29th November 2017

Town and Country Planning Act 1990 Site at 13 Kemplay Road, London. Application ref: 2015/4373/P.

Superseded proposed street elevation

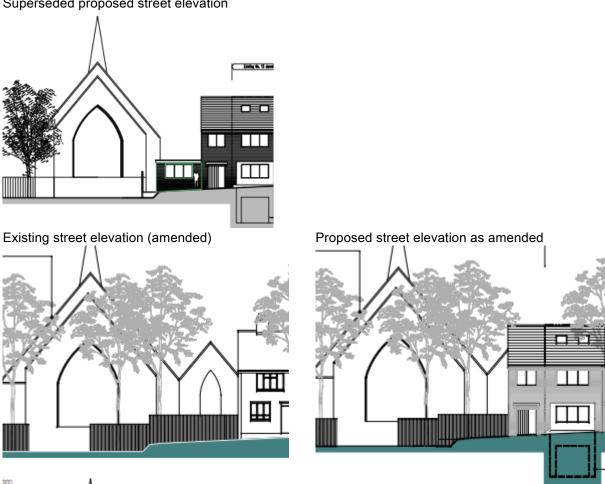
Residents have sent me a photo, taken in March 2014 (see overleaf) when the trees at the side of the application property are not in leaf. The photo shows a clear view across the application site to the main body of the chapel and the original side annex. The annex with its stained-glass window complements the form and setting of the principle gable. It is clearly visible from the street.

It is important to compare the superseded street scene drawing with the latest street scene drawings (see below). The superseded, proposed street elevation clearly shows no interference with any part of the chapel. The committee report for the April planning committee meeting, mentions views across the garden of No. 13, but it does not mention this side annex, instead it focuses upon the impact of the proposed dwelling on the main gable and the spire.

This does not necessarily mean that the assessment failed to take this part of the chapel into account. However, it would be reasonable to assert that any recommendation would also be guided by the submitted plan drawings, including the superseded street elevation, which shows a comfortable gap between the new building and the chapel. Now there is no longer a gap, it is evident the view of the chapel will be obscured by the building.

I would assert that in this case the loss of view is important. The annex has a slight setback from the principle gable so the attached photo accurately depicts what is the last remaining view where the full extent of the chapel can be appreciated from the street. It will be blocked by the proposed dwelling.
